**TEDS EXCEPTION SUBMITTAL
DISTRIBUTION LIST**

File #: TED - 2009-004
Date of submittal: 12/31/08
Site location: 415 30th Road
Parent Project: Pear Park
Name: Village
File No.: PFP-2008-178

Transportation Engineering Design Standards (TEDS) Exception Request

City File No.: _____ (To be filled in by City Staff)
Project: Pear Park Village Subdivision
Site Address: 415 30-1/4 Road Grand Junction, CO 81504
Applicant: Jobhandler Construction
Representative: Jana Gerow
Date: 12/31/08
Parent Project:
Project Name: Pear Park Village Subdivision
City File No.: _____

PARKING PLAN LOTS 14, 15, 16, 17

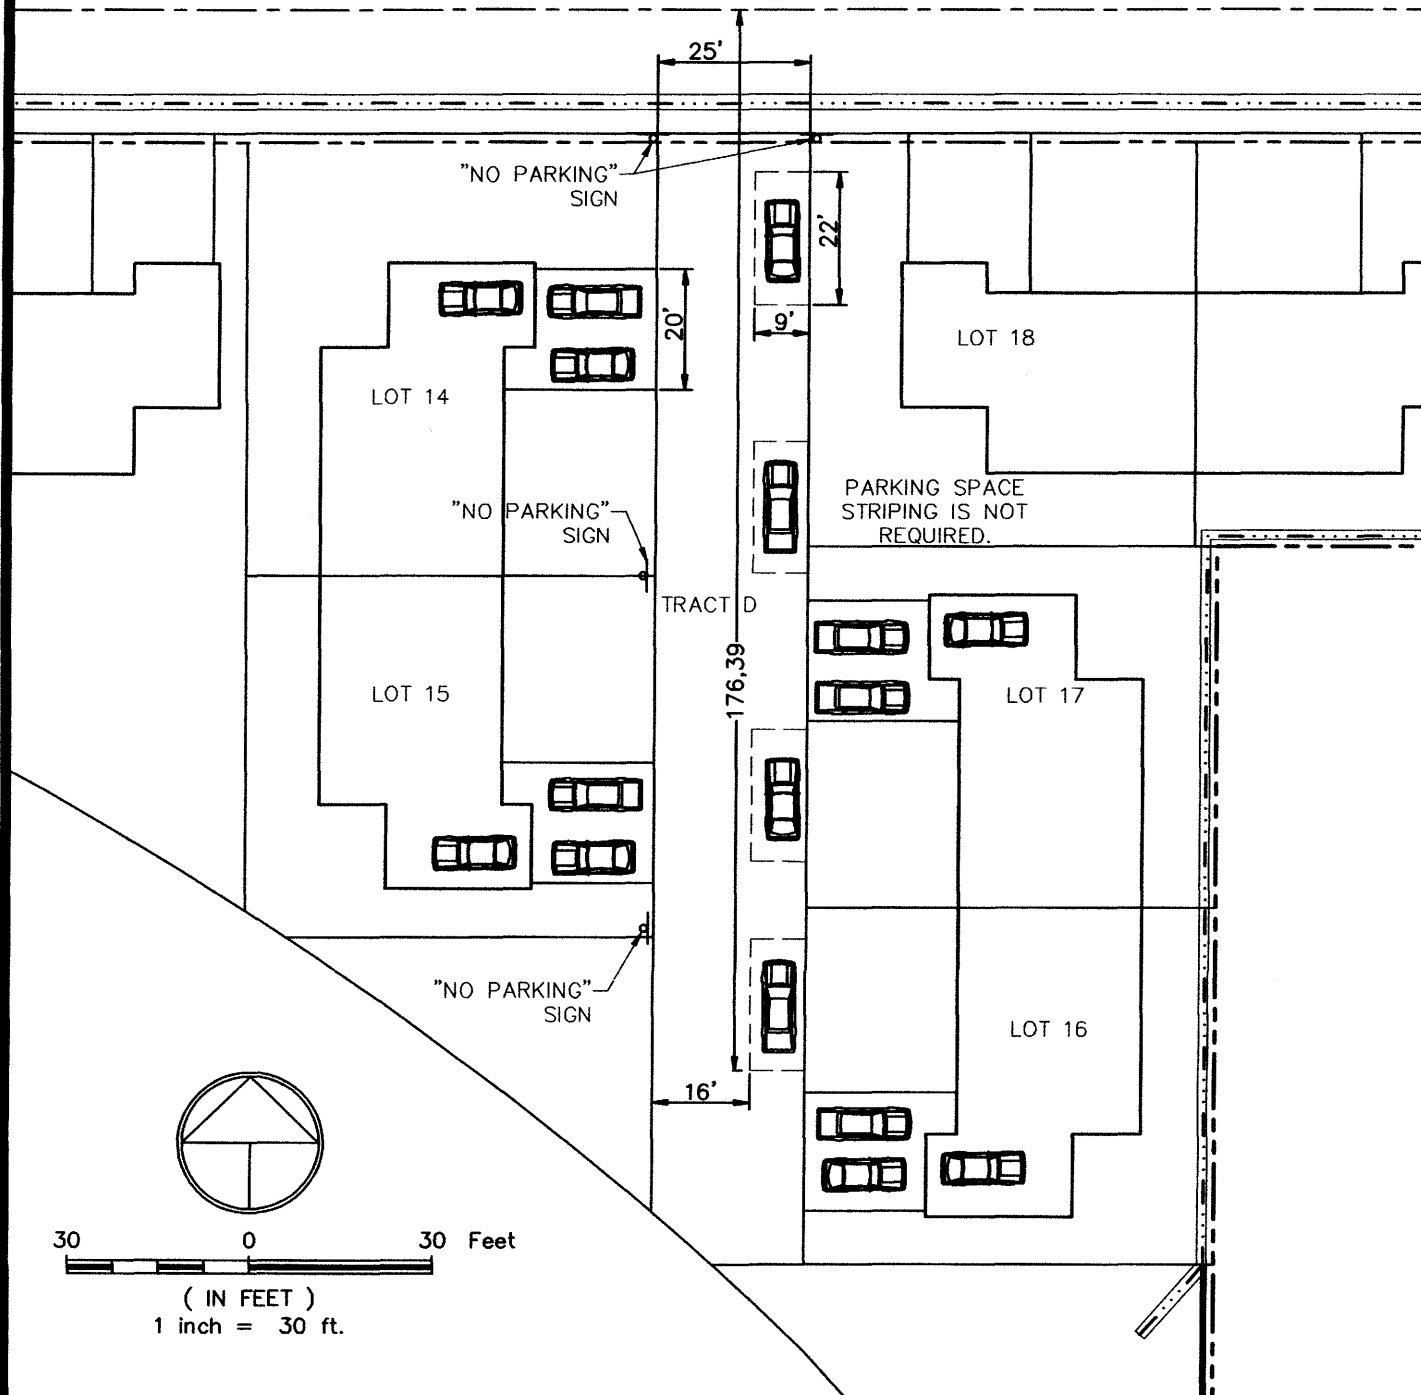
REQUEST #3 – TEDS 13.2.1.4. parking on shared driveways shall be prohibited. The shared drive street width has been widened to 25 feet (9 feet in access of the 16' minimum) to allow for the required 4 parking spaces per unit on the shared drive

The TEDS requirement for 13.2.1.4 ca not be met under the proposed configuration. A combination of the small lots (R-8 zoning) and the general site constraints does not allow the site to comply with section 13.2.1.6 (4 parking spaces per unit). The design is based on Section 13.2.1.3 (16' minimum width)

and 4.3.2.1 (parking stall dimensions, 22.0' x 9.0'). As seen in the included exhibits, there is a 16' drive isle and parking on one side of the street resulting in the 25' wide section. This configuration complies with Section 13.2.1.6 with 2 parking spaces in the driveway, 1 space in the garage and the last space in the parking isle of the shared driveway. The second exhibit shows the backing movement from the residence's driveway into the shared driveway without impact to the "on street" parking.

TEDS Exception Request #3: TEDS 13.2.1.4 – Request to override the prohibition of parking on shared driveways.

- N/A – no exception required
- Approve as requested.
- Approve with the following modification(s): _____
- Deny.
- Hold until the following additional information is submitted and reviewed:

AUTOTURN ANALYSIS

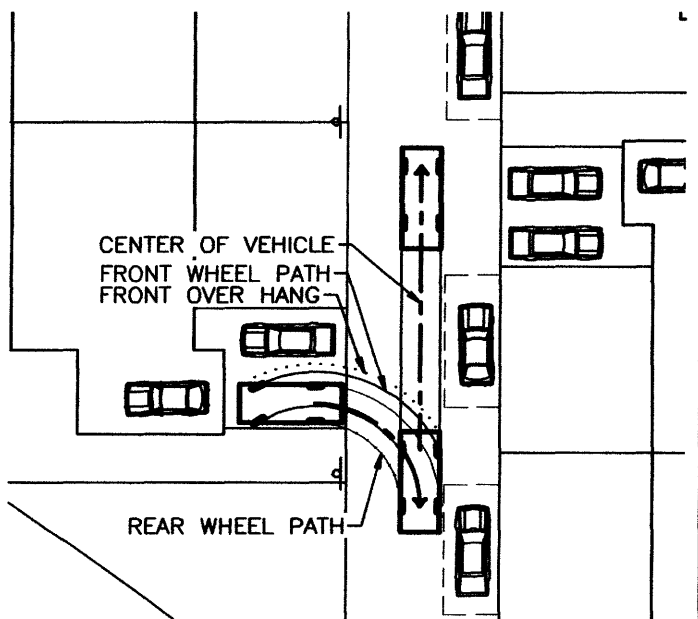
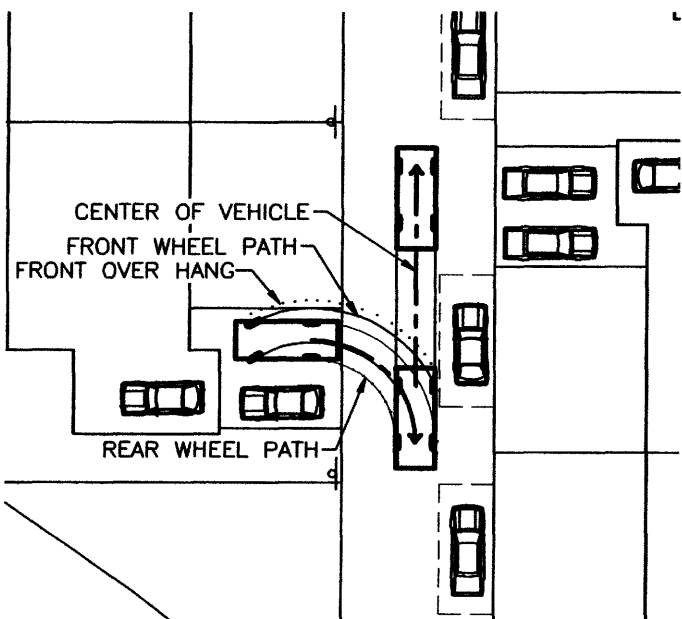
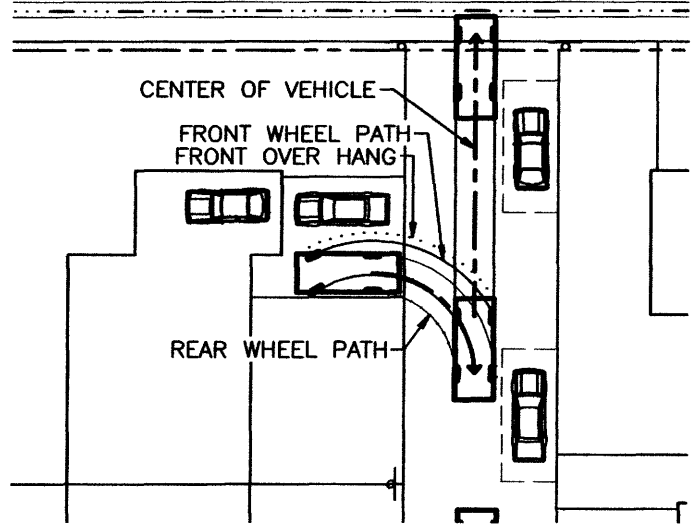
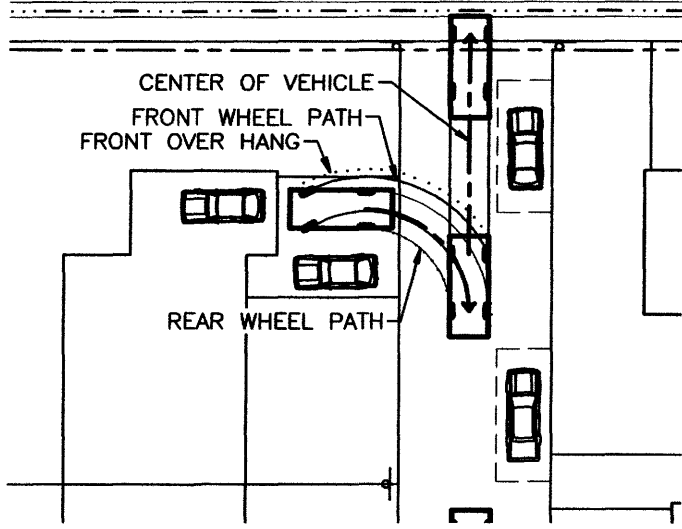
TEDS Fire Department Access A.1, dead end access greater than 150', the length of the shared driveway in Pear Park is 187.20 feet.

The Fire department has reviewed this exception and does not have issue with the requested extension (confirmed w/Hank Maesterson). The drive design meets the standards for the department other then length, giving clear access for the fire trucks to reach all homes. This request should be granted to allow for the lots and homes as designed. Should this exception not be granted, the number of houses on this street would have to be reduced by 2 and / or the lot widths modified and house designs changed. The benefits of granting the exception are the development moves forward with minimal exceptions and provides an efficient and reasonably designed subdivision allows for more affordable housing within the Pear Park area. The TEDs amendment cannot be met due to the irregular shape of this property and the limited access options from surrounding properties.

TEDS Exception Request #2: TEDS Fire Department Access, A.1 – Request to allow a shared driveway 187.20 feet long, greater than the 150' limit.

Approve as requested.
